1968 Corvette: Service Bulletin: General Information

Subject: 1968 Corvette General Information
Model and Year: 1968 Corvette
Source: Chevrolet Dealer Service Technical Bulletin
Bulletin No: 68-T-43
Section: XV
Date: April 24, 1968

Subject: 1968 CORVETTE
GENERAL INFORMATION

Astro Ventilation - Poor Air Flow

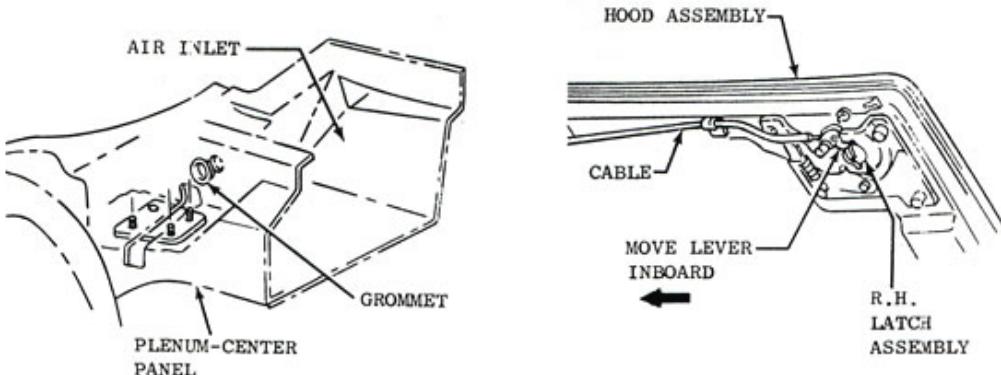
The amount of air flow through the Astro Ventilation System may be restricted if the flapper type valves are improperly cemented to the valve frame. These valves are located under the rear deck and should swing freely as pressure builds up in the passenger compartment.

In instances where the valve action is restricted, separate the rubber flaps from the frame along the bottom and sides. The Astro Vent ducting and cowl kick pad vents should also be checked for leakage as this will reduce air flow at the nozzles.

Rear Bow Lock Remote Control Cable Rattle

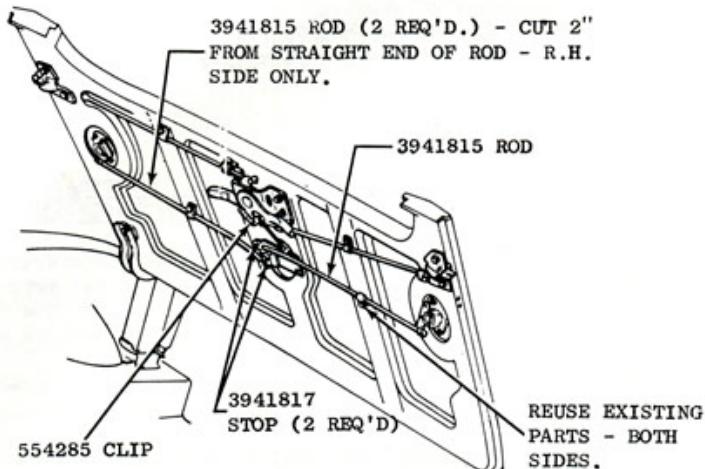
Remote control cables used on early 1968 Corvette Convertible models could rattle against the rear compartment lid. Production replaced these cables with rods on 1/2/68.

Complaint vehicles may be updated by installing the rear bow lock remote control rods as indicated on the sketch below.

Headlamp Doors - Inoperative

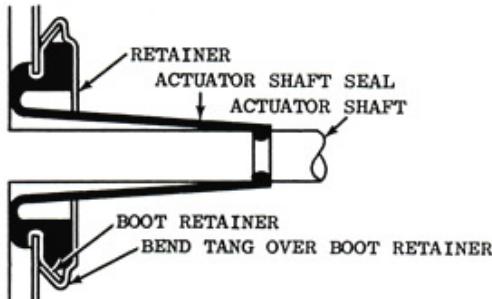
Headlamp doors which become inoperative due to sticking actuator shaft seals, should be corrected by replacing the inner shaft seal. This seal, in some cases, will stick to the actuator shaft causing the seal to pull out of the actuator. The headlamps may be operated manually as outlined in the 1968 Corvette Owners Manual when this occurs. The new style actuator seals went into production effective with Serial No. S410514. The actuator seals may be replaced as follows:

1. Remove actuator assembly per Section 12, Chassis Service Manual
2. Remove the outer boot from the actuator
3. Remove the inner seal and wipe the seal flange and actuator shaft dry
4. Installation and lubrication of actuator shaft seal
 - a) Install seal using protective cover over shaft threads (protection is needed to avoid cutting of internal seal bead by threads)
 - b) Make certain seal grommet is properly seated in the actuator cover and interior bead at small diameter of seal fits in the groove on the shaft (See sketch)
 - c) Apply a liberal film of silicone lubricant over entire exterior surface of actuator shaft seal, excluding grommet
5. Install the retainer by bending the three (3) tabs over edge of boot retainer. (See sketch)

IMPORTANT: Do not distort boot retainer when bending over the tabs. If distorted, leakage can occur
